- 2. Morning Panorama Subdivision #2; KPB File 2022-058**
Johnson Surveying / Rahman
Location: Morning Circle
Salamatof Area

Morning Panorama Subdivision #2 Preliminary Plat

ITEM 2 - MORNING PANORAMA SUBDIVISION #2

KPB File No.	2022-058
Plat Committee Meeting:	May 23, 2022
Applicant / Owner:	Hafiz Rahman of Salt Lake City, UT
Surveyor:	Jerry Johnson / Johnson Surveying
General Location:	Morning Circle, Salamatof area

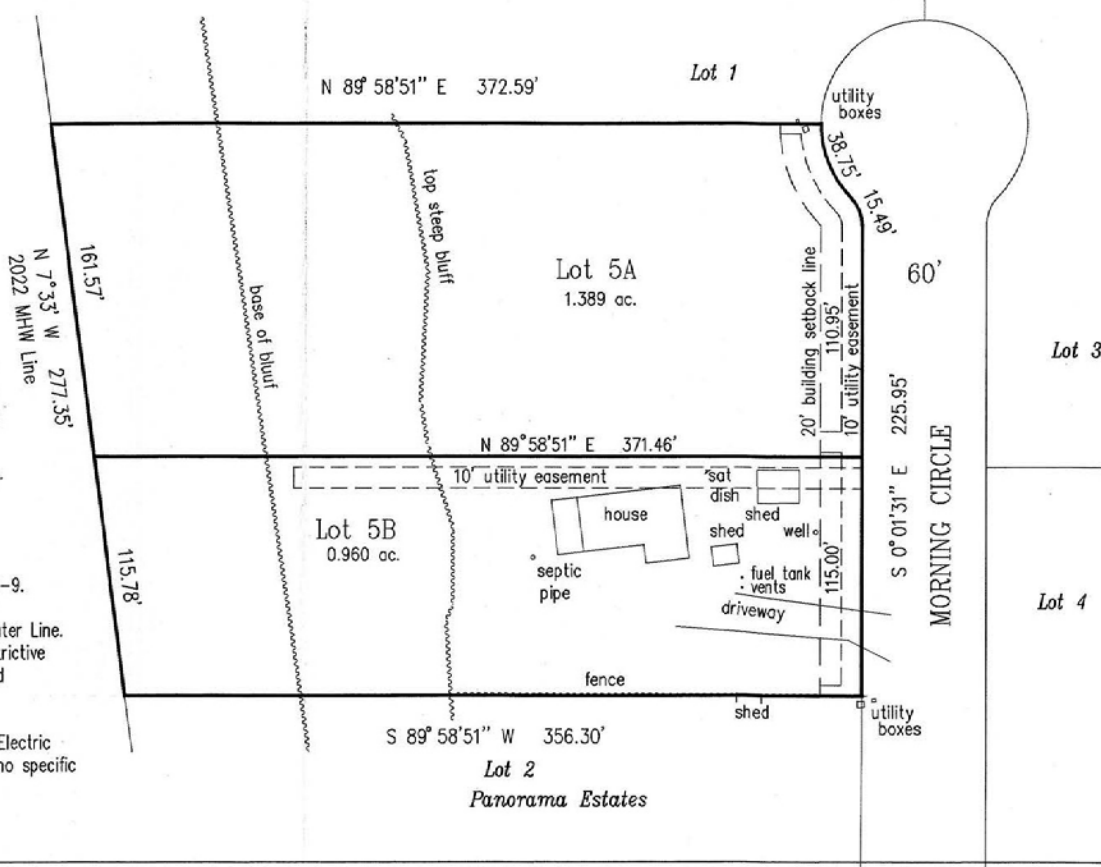
Site Investigation: Steep terrain can be found within the western portion of the preliminary plat. The surveyor has indicated the top and base of the bluff. **Staff recommends the depiction of the bluff remain on the final plat.**

The preliminary plat is within a floodplain zone. **Staff recommends a floodplain note be added to the plat that includes the reference to the map panel.**

Numerous improvements are depicted on the preliminary plat with all remaining within proposed Lot 5B. A portion of the house and a shed appear to be within a 10 foot utility easement within the northern portion of proposed Lot 5B. A satellite dish is also within that easement. The easement was granted by Panorama Estates Subdivision, Plat KN 80-80. KPB Assessing records indicate that the house was possibly built in 1980. The encroachments into the utility easement may be dealt with in numerous ways.

Lot 5B does not comply with the 3:1, depth to width ratio. An exception has been requested.

This plat is carrying over the utility easements previously granted. Due to the various plats granting the easements, the surveyor is noting he carried them over from the previous plat, Plat KN 2019-9. This plat will have the utility easements increase to 20 feet within 5 feet of the side lot lines. **Staff recommends** the 10 foot utility easement within Lot 5B include "granted by Plat KN 80-80", and adjust the depiction of the utility easements within 5 feet of the side lot lines as they appear to be off.

The comment from HEA is referring to what appears to be the inaccurate depiction to the side lot lines. If this is not what the depiction is referring to, then remove or note the creation of the easement.

HEA	This portion of the easement does not appear to be from any record plats. Either remove or state that the 10 x 10 square is being granted by this plat.
ENSTAR	No comments or objections
ACS	No objections
GCI	Approved as shown

- G. The status of adjacent lands within 100 feet of the proposed subdivision boundary or the land status across from any dedicated rights-of-way that adjoin the propose subdivision boundary, including names of subdivisions, lot lines, block numbers, lot numbers, rights-of-way; or an indication that the adjacent land is not subdivided;
Staff recommendation: Provide a label for Lot 3A and update label to Lot 3B. The subdivision for those two lots is Morning-Holm Subdivision, provide a subdivision name label for the two lots. Lot 4, located south of Lot 3B is from the Panorama Estates subdivision and should have a label added.

Staff recommendation: Adjust the shared lot line so it is not the same as the subdivision boundary.

Correct plat note 5, the Book should be 206 and correct "file" to "filed".

Within plat note 5 and 6 capitalize "book" and "page" throughout the notes to be consistent.

Staff Discussion: KPB Code 20.30.190 states that the depth of a lot shall be no greater than three times the average width. The ratio for Lot 5B is 3.2:1.

Staff recommends the utility easement encroachments be resolved by one or a combination of the following

- Remove the encroachments from the utility easement.
- Petition to have the utility easement removed by filing for a utility easement alteration to be heard by the KPB Planning Commission.
- Determine if the structures predate the creation of the utility easement. Provide documentation, depict the structures on the plat, and add a plat note that the structures predate the utility easement.

Staff recommendation: *Place the following notes on the plat.*

- **FLOOD HAZARD NOTICE:**
Some or all of the property shown on this plat has been designated by FEMA as a flood hazard area district as of the date this plat is recorded with the district recorder's office. Prior to development, the Kenai Peninsula Borough floodplain administrator should be contacted for current information and regulations. Development must comply with Chapter 21.06 of the Kenai Peninsula Borough Code. Map Panel: 02122C-0105E

- *Acceptance of this plat by the Kenai Peninsula Borough does not indicate acceptance of any encroachments.*
- *If it is determine the encroachments were prior to the creation of the utility easement add, 'Improvements on Lot 5B predate the 10' utility easement created by plat KN 80-80 and are not subject to the utility easement. Any replacement, or improvement, to the building must comply with the 10 foot utility easement as shown on this plat.'*

- *Provide a plat note for any exceptions granted.*
- *Include the code compliant Wastewater disposal notes.*
